Process Sheet

Customer : CC-DAR01 Dart Aerospace Ltd.	Drawing Name : REWORK
Job Number : 36067	
Estimate Number : 10804	
P.O. Number : N/A	Part Number : D205596103
This Issue : 29/11/2007 S.O. No. : N/A	Drawing Number : ECN 1075/DSI 9396
Prsht Rev. : NC	Project Number : N/A
First Issue : N/A Type : LANDING GEAR	Drawing Revision : N/A
Previous Run : 36066	Material : N/A
Written By : _____	Due Date : 20/12/2007 Qty: 1 Um: Each
Checked & Approved By : _____	
Comment : _____

DART SERVICE INSTRUCTION

A	NEW ISSUE	MB	07.11.16
REV.	DESCRIPTION	BY	DATE
DESIGN		DART AEROSPACE LTD	
DRAWN		HAWKESBURY, ONTARIO, CANADA	
CHECKED		DRAWING NO.	REV. A
MFG. APPR.		DSI 9396	SHEET 1 OF 2
APPROVED		TITLE	SCALE
DE APPR.		CROSSTUBE SUPPORT CHANGE	NTS
DATE	07.11.16	COPYRIGHT © 2007 BY DART AEROSPACE LTD THIS DOCUMENT IS PRIVATE AND CONFIDENTIAL AND IS SUPPLIED ON THE EXPRESS CONDITION THAT IT IS NOT TO BE USED FOR ANY PURPOSE OR COPIED OR COMMUNICATED TO ANY OTHER PERSON WITHOUT WRITTEN PERMISSION FROM DART AEROSPACE LTD.

FIGURE 1: INSTALLATION OF SUPPORT ON CROSSTUBE

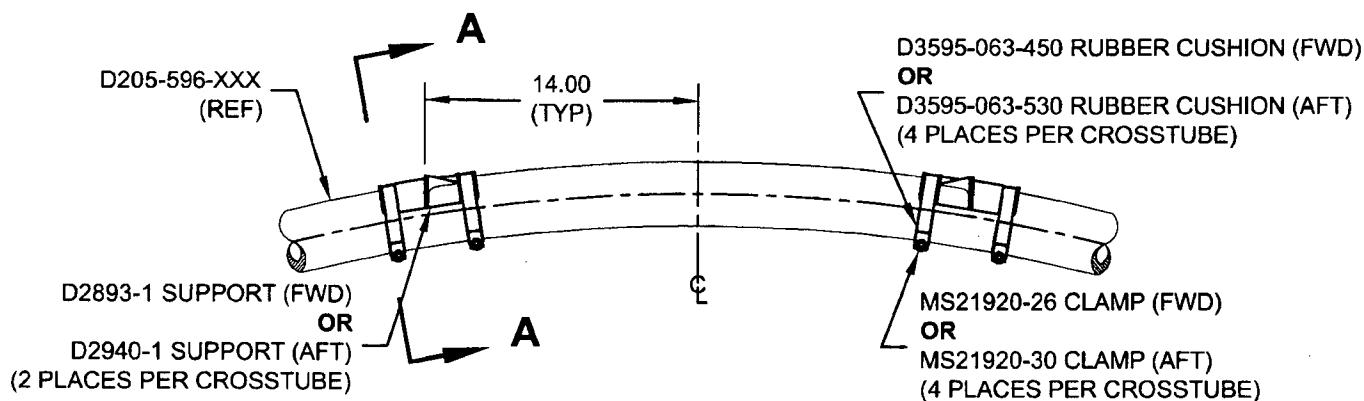
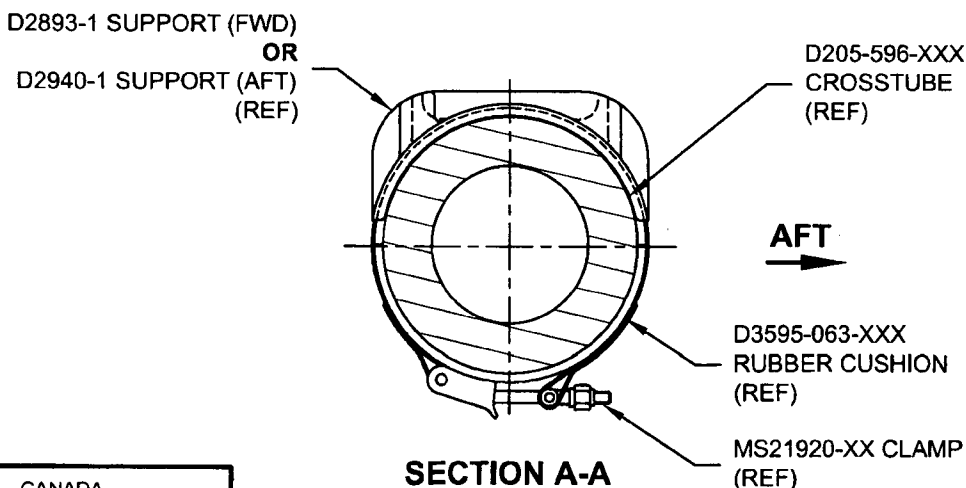
To prevent the supports from shifting on D205-596-101/-103/-105/-107 Crosstubes at CHG 001, the D2893-1 or D2940-1 Supports should be removed and re-installed as follows:

- Apply a 0.03" to 0.06" thick layer of Magnobond 6398 underneath D2893-1 or D2940-1 Supports and re-install the Supports on the crosstube as shown in Figure 1. Install a D3595-063-450/-530 Rubber Cushion on each MS21920-26/-30 Clamp. Position and secure the D2893-1 or D2940-1 Supports on the crosstube using MS21920-26/-30 Clamps. Torque clamps to 80-100 in-lb. Let the D205-596-101/-103/-105/-107 Crosstube Assembly cure before re-installing the crosstube on the aircraft.
